## RESPONSE TO REQUEST FOR INFORMATION (RRFI) NO. 048

| <b>PROJECT:</b>    | 2299 Dundas Street West, Toronto, Ontario<br>Shelter Renovation | <b>RJC NO.</b>       | TOR.122388.0002      |

| <b>Subject:</b> | Consult RFI 10 - Level 2 Partition Issues |

Level 2 partition issues

SECOND FLOOR PLUMBING

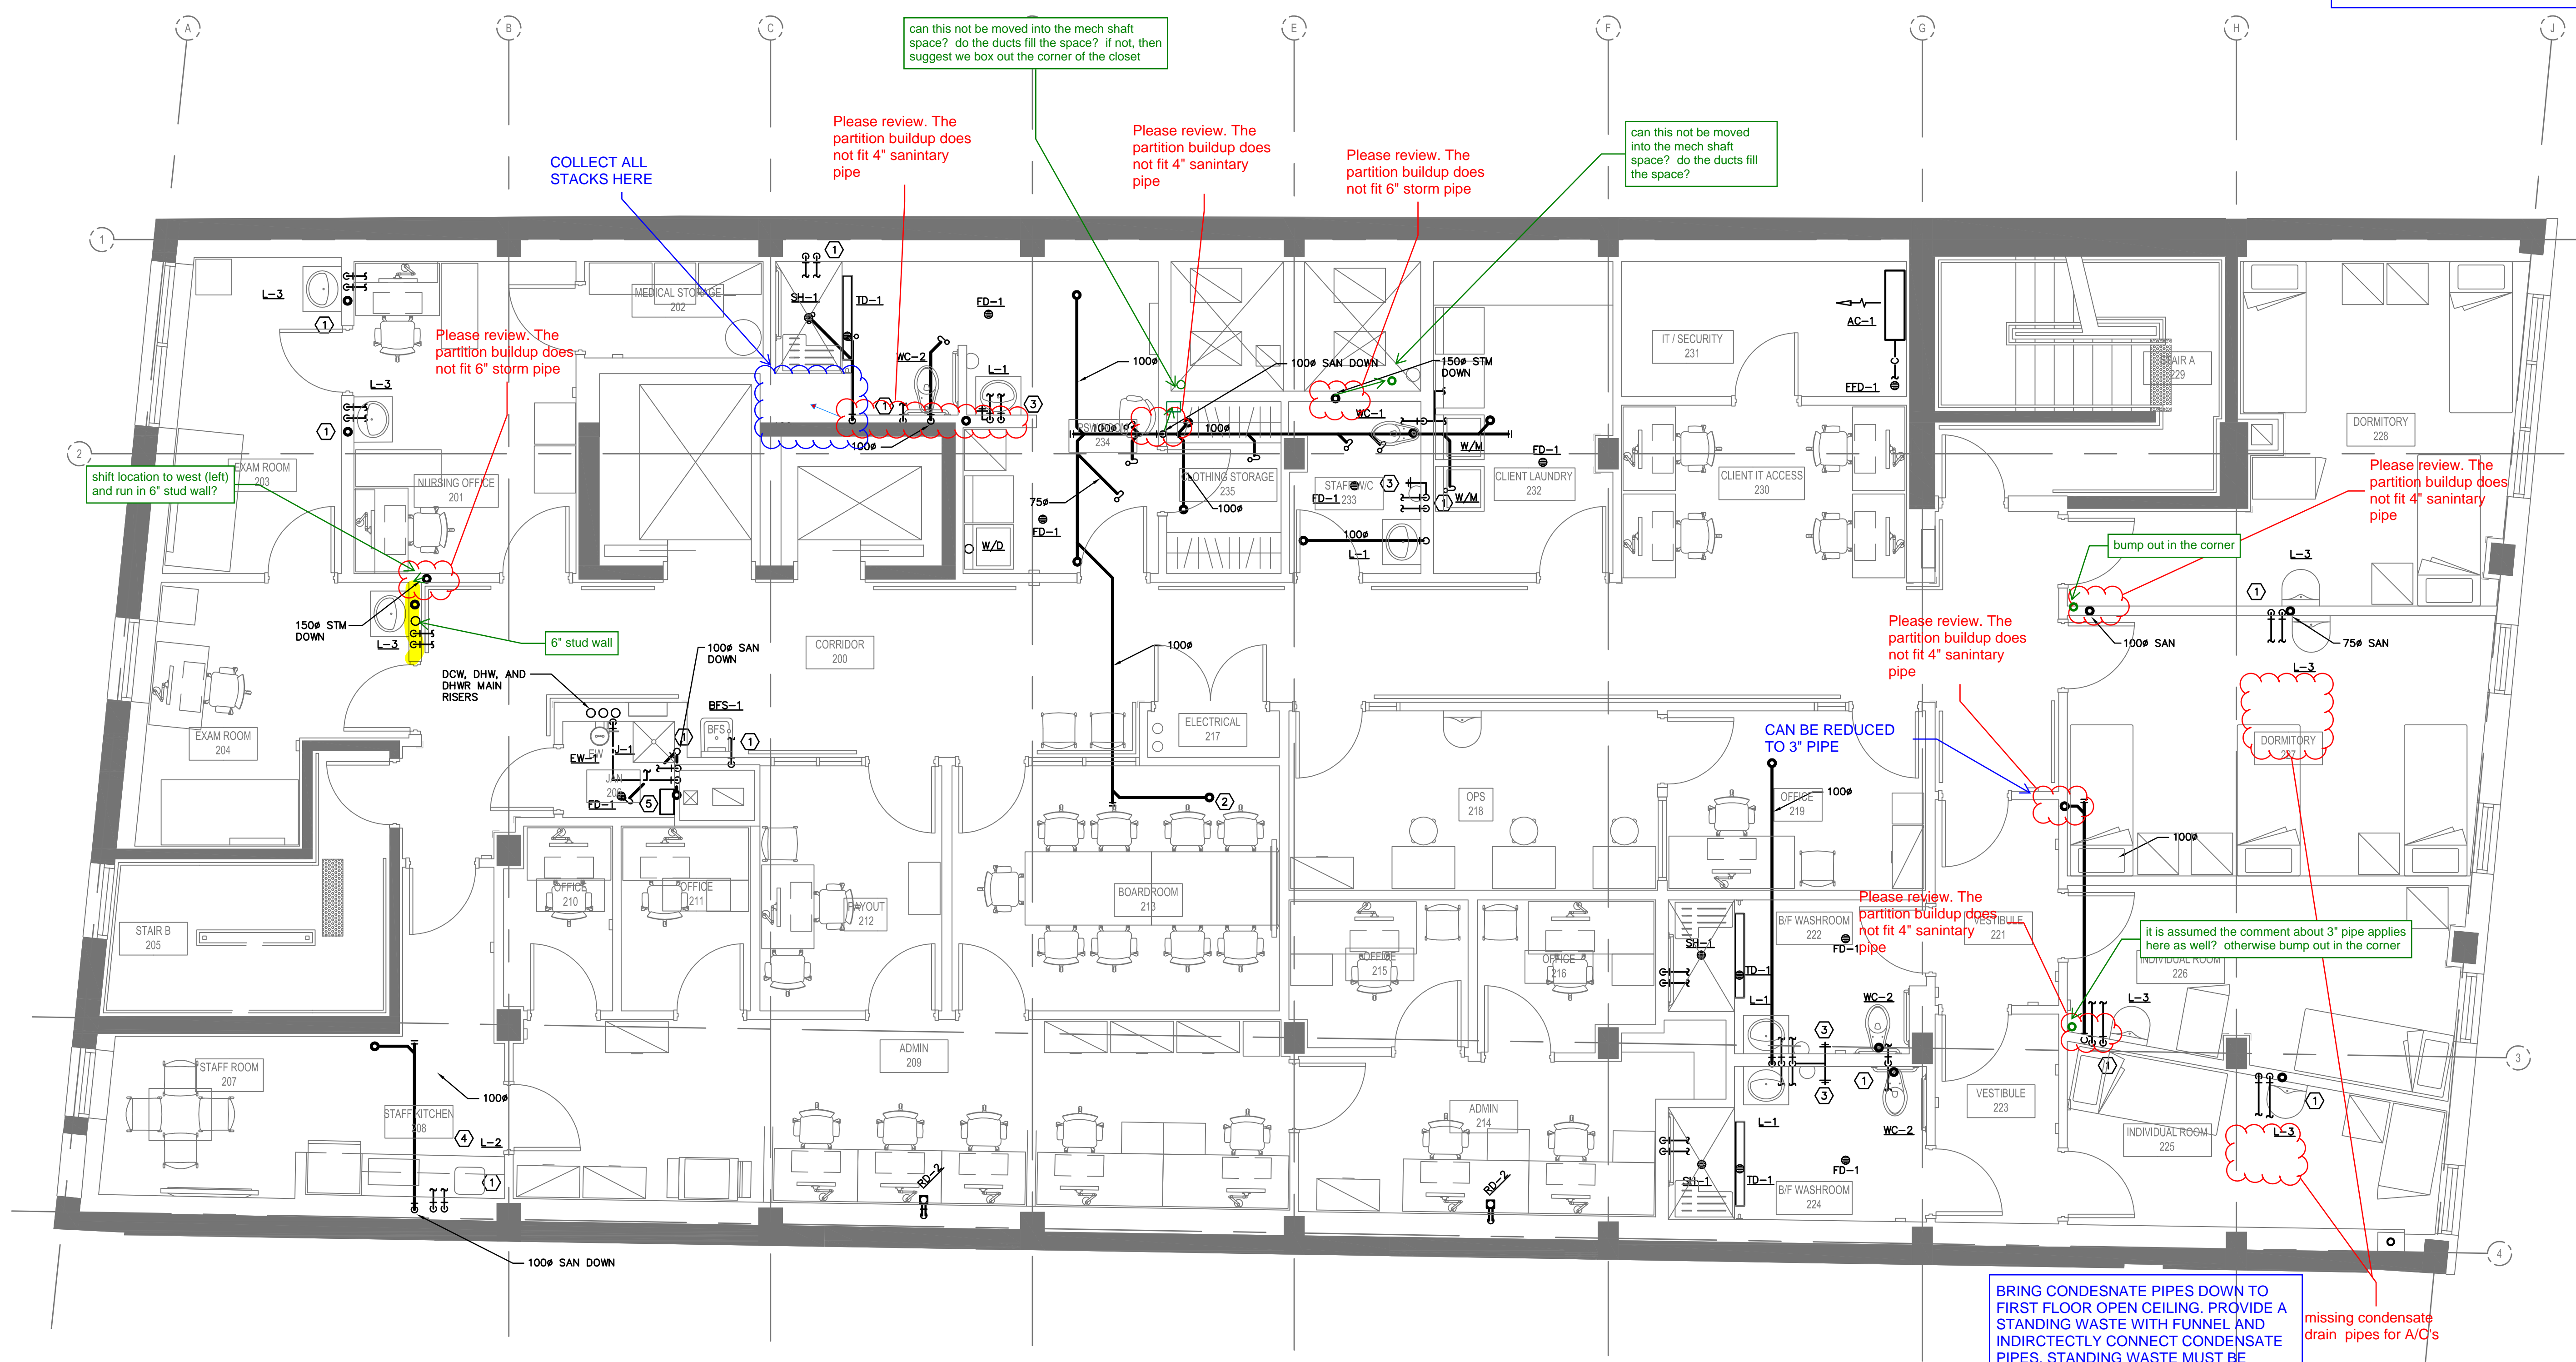
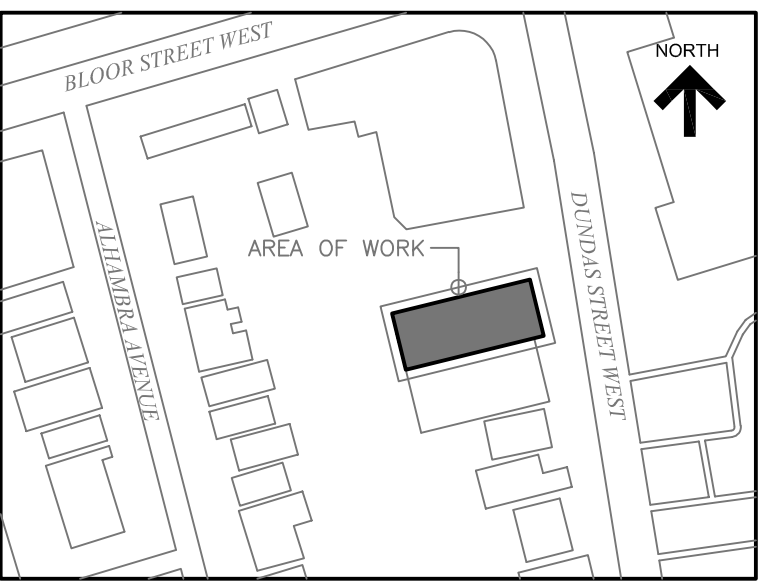
Please refer to the attached and advise.

PLUMBING VENT TO BE INSTALLED AS PER OBC

DTAH Comments  
2024-08-23

HIDI Comments  
2024-08-22

Second floor LAVs:

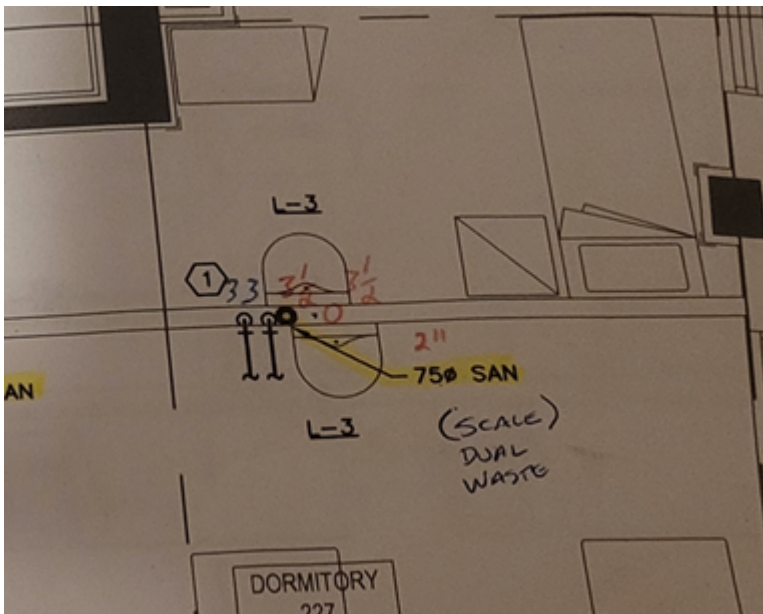
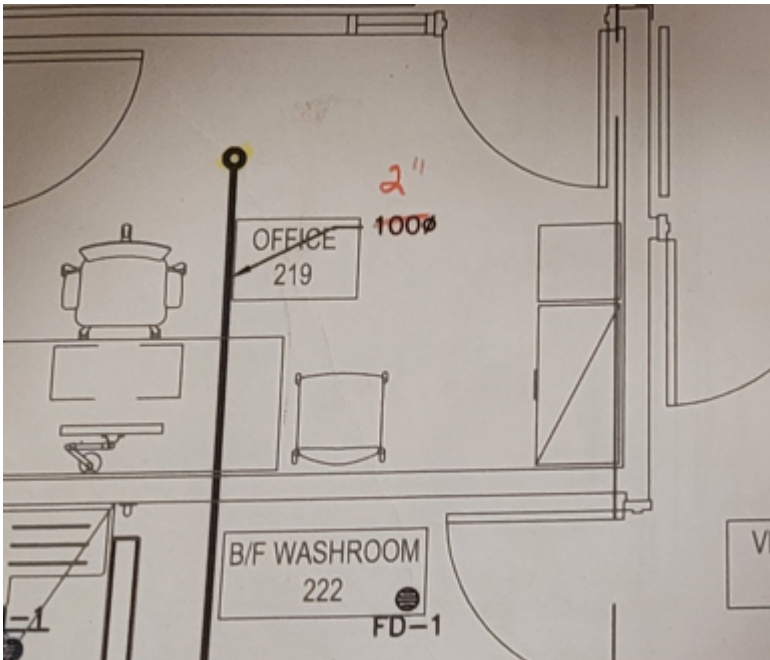
Thanks Mina, however the 6" vertical will not fit in the pipe space. 4" vertical Will allow for 10800 litres. Please let me know if we can go ahead and core based on that size

We are ok with the changes to the pipe sizes shown in the markups.
